MASTERPLAN LEVELS

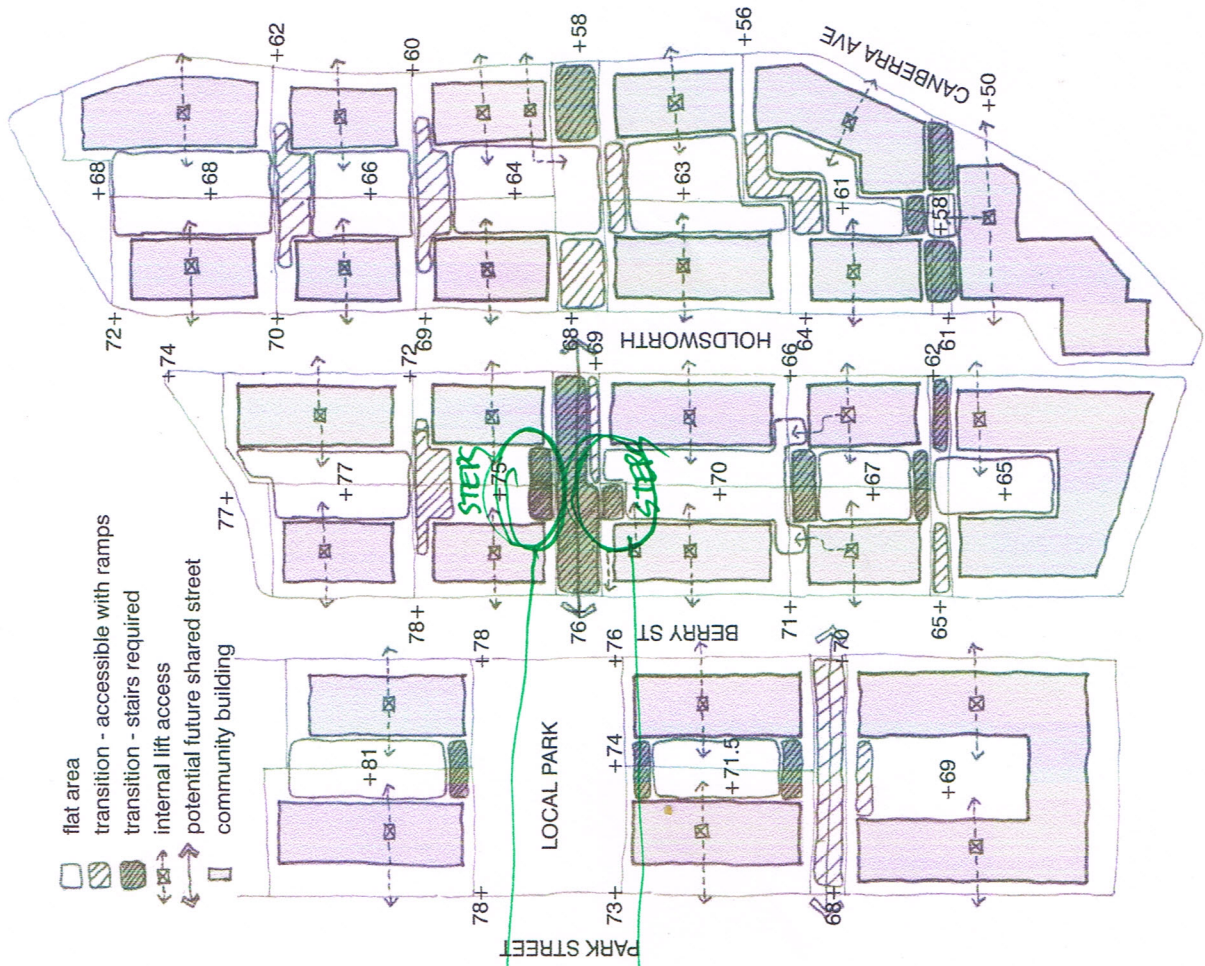
PLAN SHOULD
SHOW THESE
STEPS ON
THE
E-W
LINK AT
INTERSECTIONS
WITH
N-S GREENY SPINES
